# ICC A117.1 Comments on 1<sup>st</sup> Draft

Proposal list to the 2017 A117.1 for the 2023 edition –  
8-31-2023  
Chapter 7 to 11

### 703.4 Braille

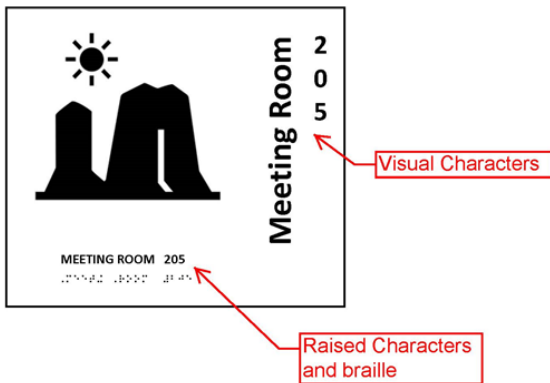
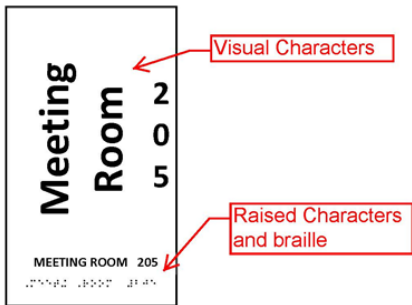
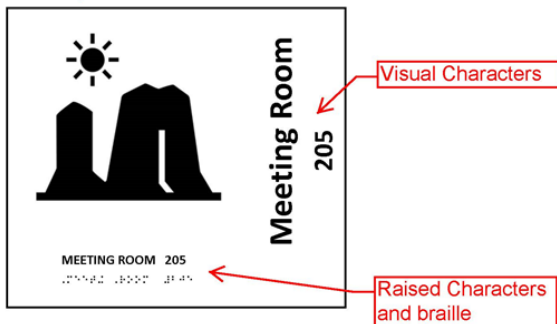
**Reason:** The reason in the original proposal did not show compliant examples, just the issue of signage. There were also concerns that the information for the braille should also include the horizontal requirement. The examples below are compliant examples.

**703.4.4 Position.** Braille shall be below the corresponding text and displayed in a horizontal orientation. If text is multilined, braille shall be placed below entire text. Braille shall be separated  $\frac{3}{8}$  inch (9.5 mm) minimum from any other raised characters and  $\frac{3}{8}$  inch (9.5 mm) minimum from raised borders and decorative elements. Braille provided on elevator car controls shall be separated  $\frac{3}{16}$  inch (4.8 mm) minimum either directly below or adjacent to the corresponding raised characters or symbols.

**Figure 703.3.10 703.1.4.4 Height of Raised Characters and Braille above Floor**

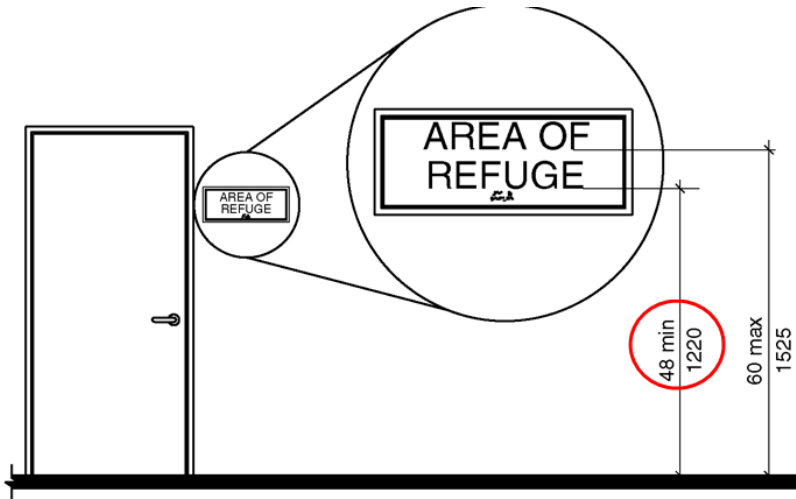
**Note: Revise Figure to indicate 48" to bottom of braille**

**703.3.10 703.1.4.4 Height above floor.** ~~Raised characters~~ Tactile characters on signs shall be 48 inches (1220 mm) minimum above the floor, measured to the baseline of the lowest raised character braille cell and 60 inches (1525 mm) maximum above the floor, measured to the baseline of the highest raised character.

FIGURE 1103.12.1.1

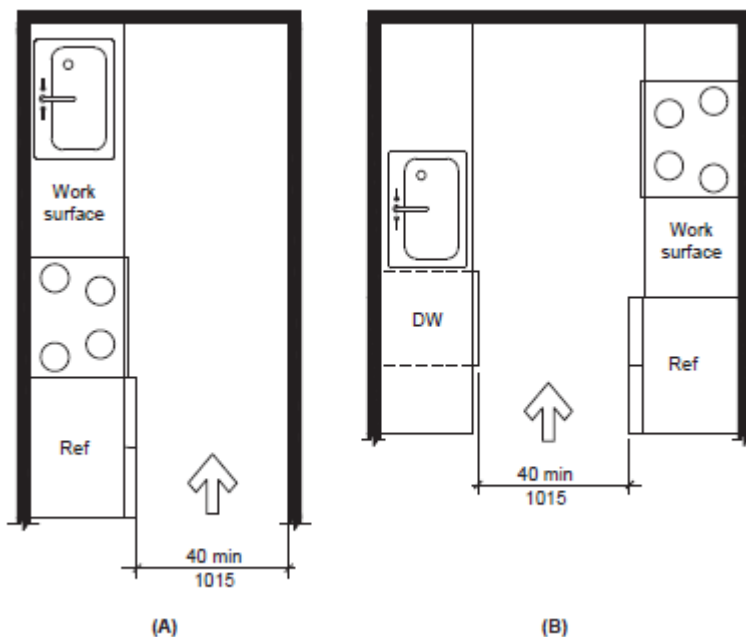
The existing figures for the Type A unit kitchens (Fig. 1103.12.1.1) provide a good illustration of what the galley kitchen provisions would allow.

**Fig. 1. Back Wall Elevation**

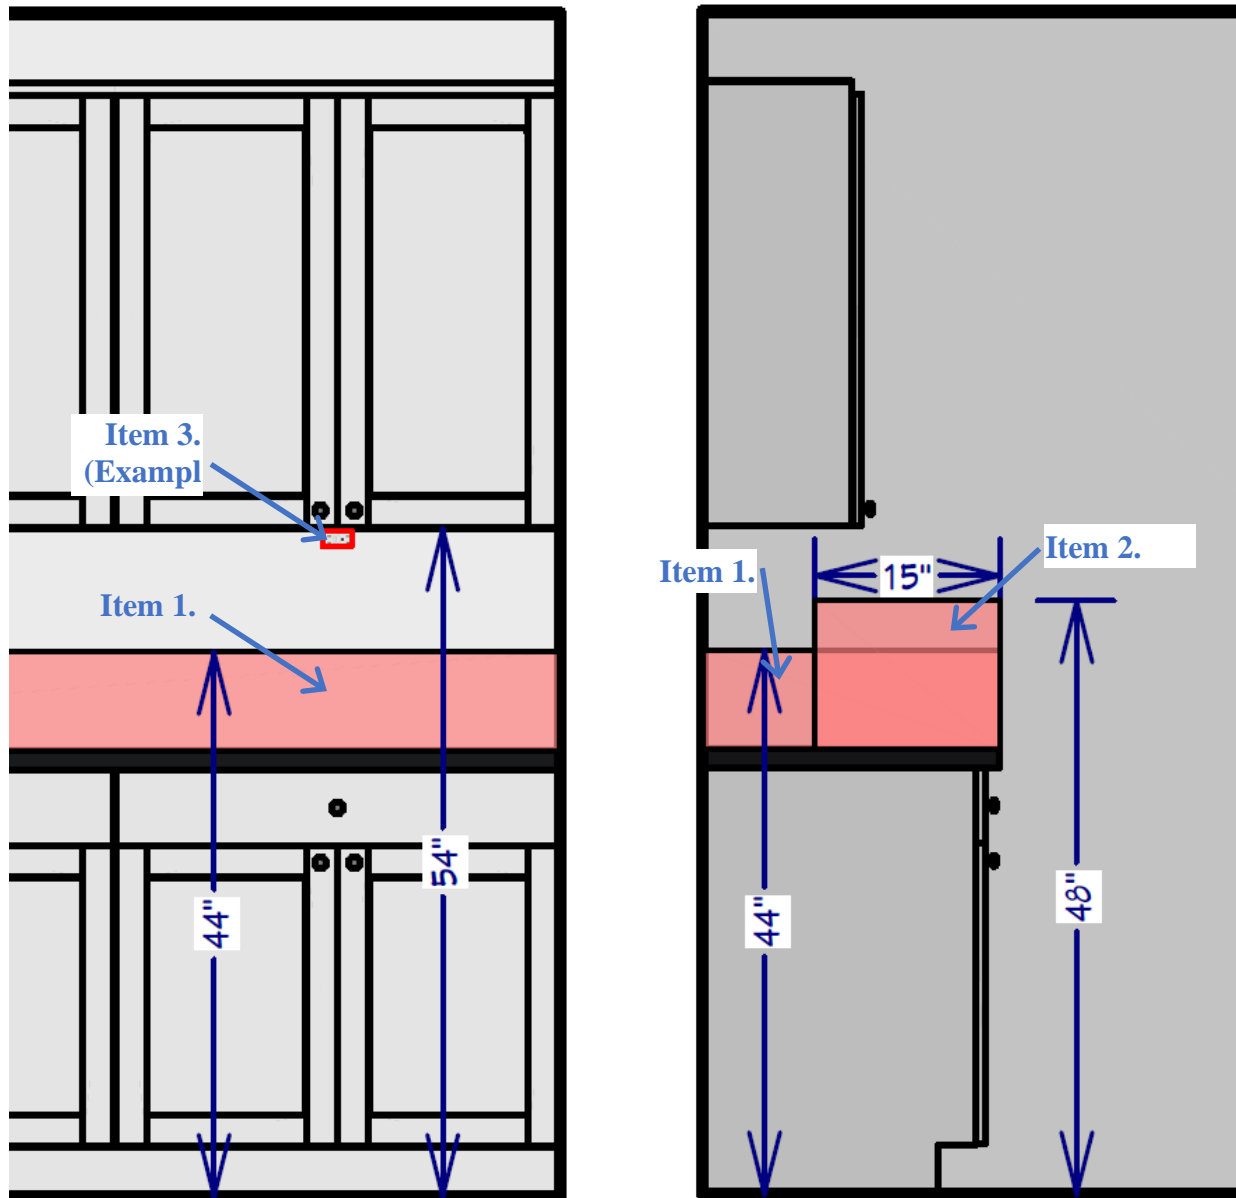
If all items in the list are adopted, this change would allow four options for receptacle outlets serving kitchen counters in Type A units once the requirement for two accessible receptacle outlets is satisfied: (1) install them at 44 inches maximum above the floor, (2) install them on a side wall at the end of a counter run 15 inches maximum from the front of the counter edge at 48 inches maximum above the floor, (3) install them at the face of the upper cabinets no more than 15 inches from the front counter edge and 54 inches maximum above the floor, or (4) fully comply with the general reach range and clear floor space requirements of the standard. (See Figures 1. and 2. below.)

**Fig. 1. Back Wall Elevation**

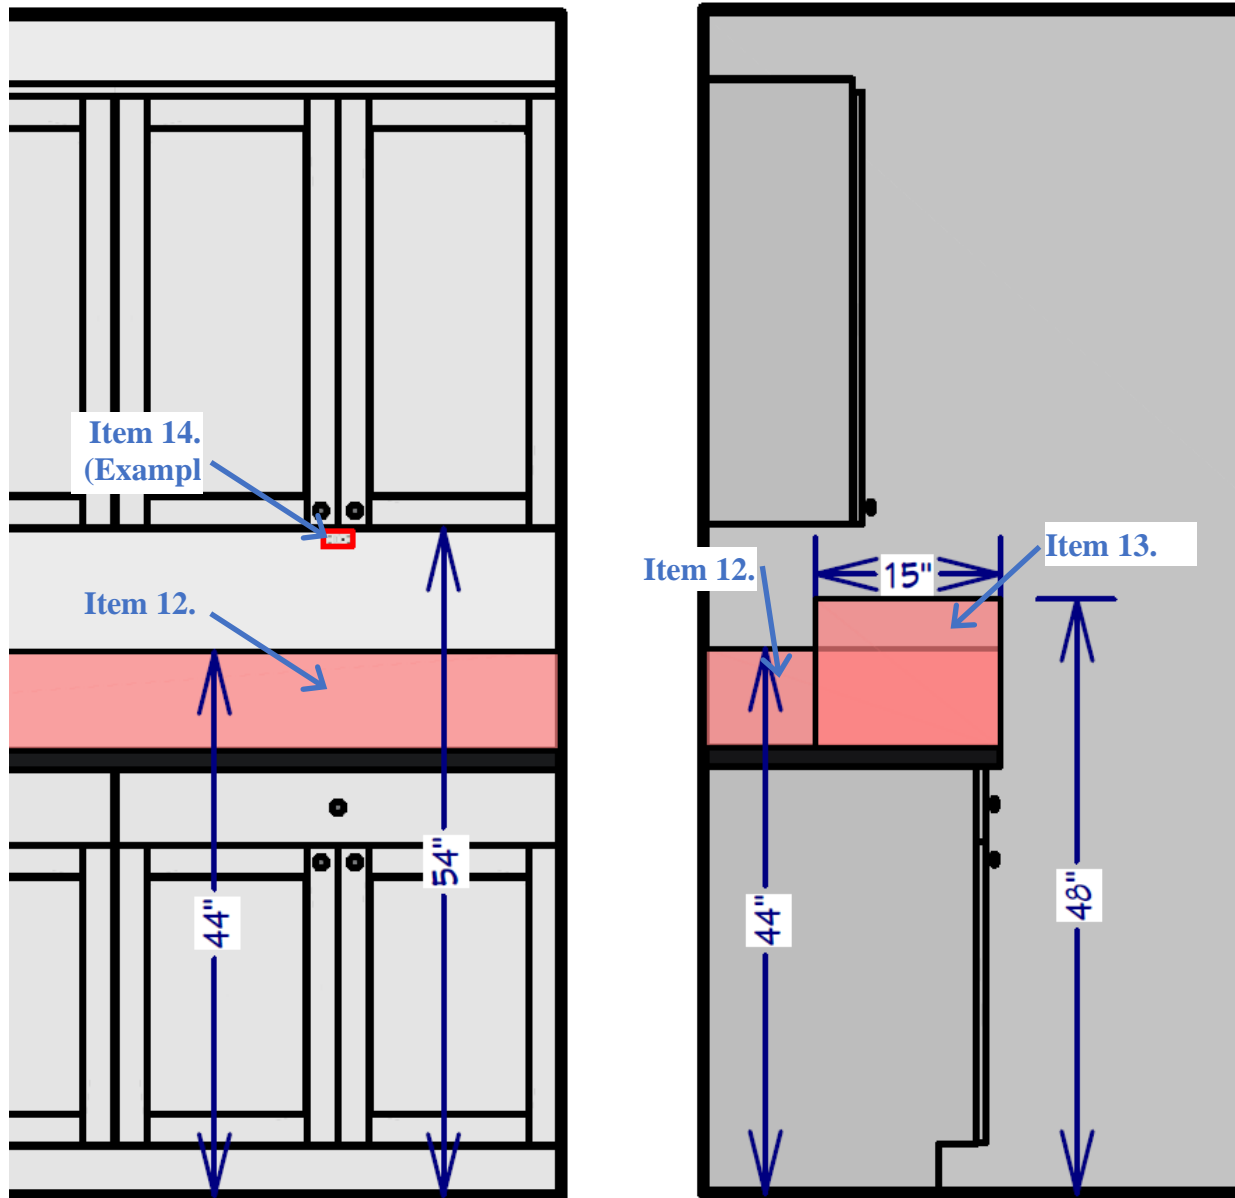
If all items in the list are adopted, this change would allow four options for receptacle outlets serving kitchen counters in Type B units: (1) install them at 44 inches maximum above the floor, (2) install them on a side wall at the end of a counter run 15 inches maximum from the front of the counter edge at 48 inches maximum above the floor, (3) install them at the face of the upper cabinets no more than 15 inches from the front counter edge and 54 inches maximum above the floor, or (4) fully comply with the general reach range and clear floor space requirements of the standard. (See Figures 1. and 2. below.)

Figure 1104.11.3.1.3.2  
Forward approach bathtubs in Type B units  
Option A bathrooms

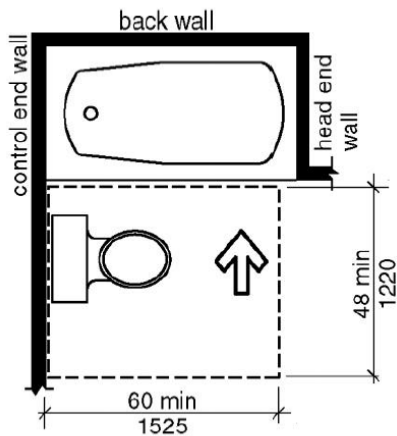
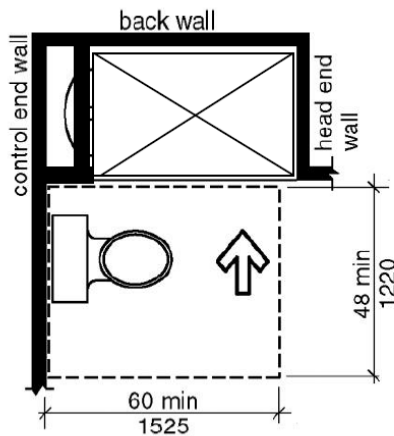
It is my interpretation that this is a safer and more accessible option. If a person in a wheelchair could approach a bathtub in this configuration, there is no reason that same approach could not be equivalent or better for a shower.

Below are what is currently permitted, and what is proposed.

**Figure 1104.11.3.1.3.4**  
**FORWARD APPROACH SHOWER COMPARTMENT IN TYPE B UNITS**  
*(Note: Figure similar to this. I don't have access to new graphic at this time.)*

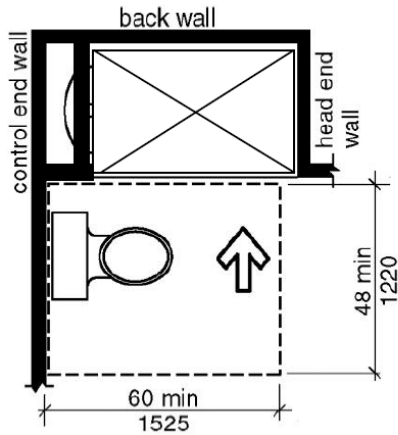
**REASON:** I had some people ask if someone installed this shower even with the water closet instead of as shown. I believe the text revision will address this concern. Measuring from the front of the water closet is not a good option, because the walls have to be in place way before the water closet is installed, and what you planned on is not always the one get gets installed. Please see the reason for the original proposal for what is permitted for tubs. We do not address smaller tubs, so this is actually a higher level of access for both clearance and not having to step over the edge of the tub.

**1104.11.3.1.3.4 Forward approach Shower compartment.** The shower compartment shall have dimensions of 30 inches (760 mm) minimum in depth and 44 inches (1120 mm) minimum in width. A clearance of 60 inches (1525 mm) minimum in length measured perpendicular from a side wall and 48 inches (1220 mm) minimum in width shall be provided in front of shower compartment with a forward approach. A water closet and a lavatory shall be permitted in the clearance at one side of the shower compartment opposite the side wall the clearance is measured from.
